**Belle Fourche Pipeline Company**  
**8-Inch Crude Oil Pipeline/McKenzie County**  
**Siting Application**

**Case No. PU-07-596**

**ORDER ON REQUEST TO AMEND ROUTE**

**North Reroute – West of Alexander**  
 Belle Fourche Pipeline  
 8-inch Crude Oil Pipeline Project  
 ND PSC Case No. PU-07-596  
 January 2008 - Revised

**EXHIBIT DRAWING**  
**8" ALEX LINE-BELLE FOURCHE**  
**SECTION 6, T150N, R101W**  
**MCKENZIE COUNTY, NORTH DAKOTA**

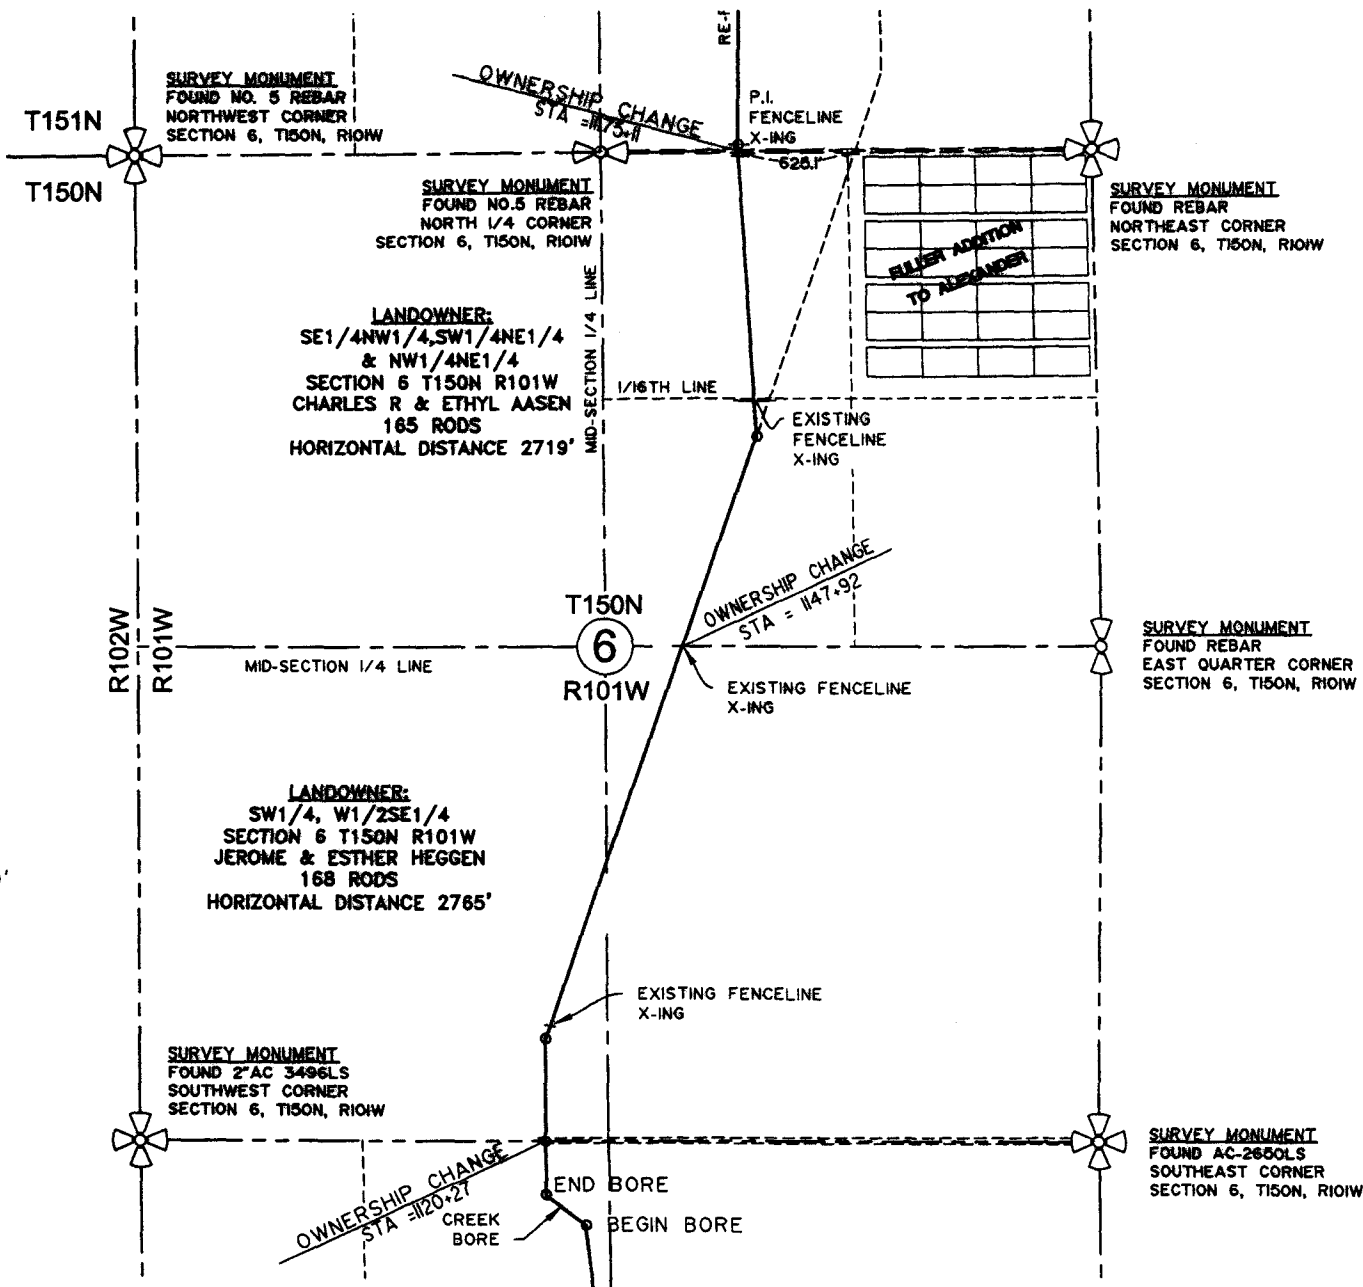
By letter dated January 8, 2008 Belle Fourche requested approval of changes in the original permitted pipeline route at Section 31, T151N, R101W and Section 6, T150N, R101W, in McKenzie County (North Reroute) and at Sections 7 and 18, T149N, R101W in McKenzie County (South Reroute) as shown on the attached maps.

Kathleen Spilman, Managing Director for Keitu Engineers & Consultants, Inc., evaluated the route changes and in a letter dated January 11, 2008 stated the North Reroute was initiated at the request of a landowner and the reroute crosses the property of the same three landowners as the current approved route. All landowners have agreed to the reroute. The North Reroute minimizes potential surface and storm water impacts by avoiding a marshy area of the water crossing, moves the pipeline further away from an occupied dwelling and developed areas of the City of Alexander, avoids routing through a landowner's stock pond and feed lot, and moves the pipeline further away from the municipal drinking wells of the City of Alexander. No new section lines or roads are impacted and a smaller impact to the Lonesome Creek water crossing is

expected. No naturally occurring woody areas or shelterbelt/tree rows or shrub areas are impacted by the reroute. The pipeline would be located even further from archaeological areas of potential exposure.

1. Belle Fourche Pipeline Company's request for changes in the transmission line route in Section 31, T151N, R101W and Section 6, T150N, R101W, and Sections 7 and 18, T149N, R101W, all in McKenzie County is granted.
2. Belle Fourche Pipeline Company is issued First Amended Route Permit No. 108.

**EXHIBIT DRAWING**  
**8" ALEX LINE-BELLE FOURCHE**  
**SECTION 7, T149N, R101W**  
**McKENZIE COUNTY, NORTH DAKOTA**

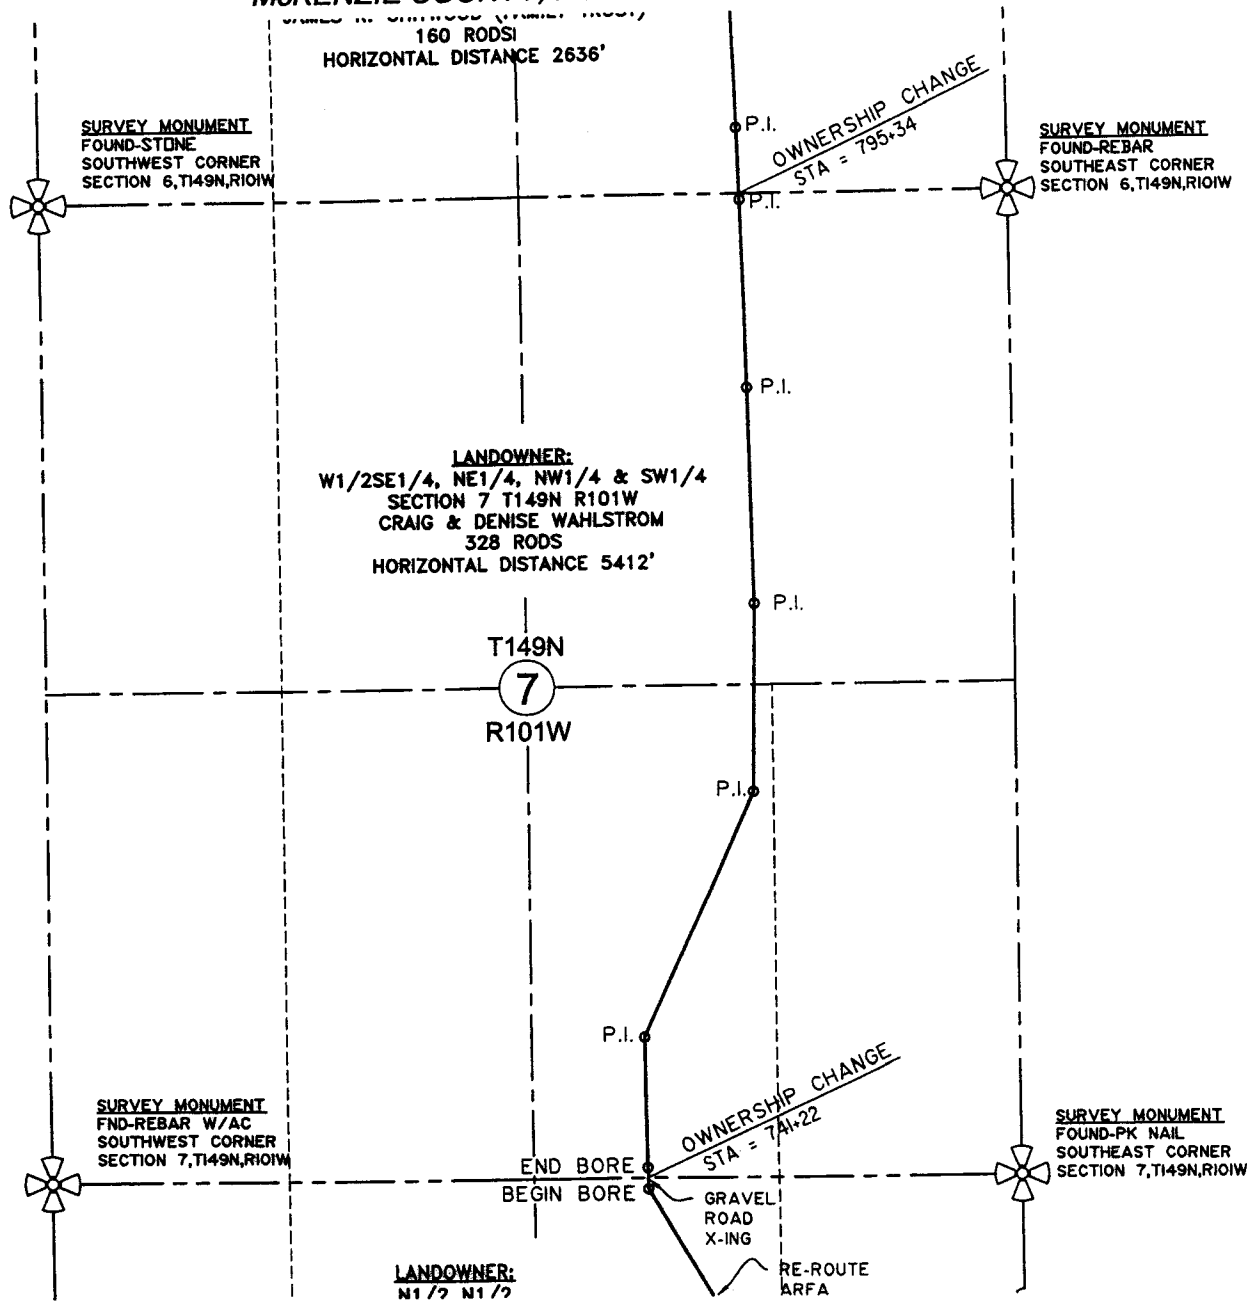
Kathleen Spilman states the South Reroute is proposed to reduce bending and stress on the pipe and increase the distance to the adjacent property line. The South Reroute crosses the property of the same landowners as the current approved route. All rural residences in the area of the reroute are more than 500 feet from the pipeline. No new section lines, roads or water crossings are impacted, no naturally occurring woody areas are impacted, no new shelterbelt/tree rows are impacted, and no archaeological areas of potential exposure are be impacted by the reroute.
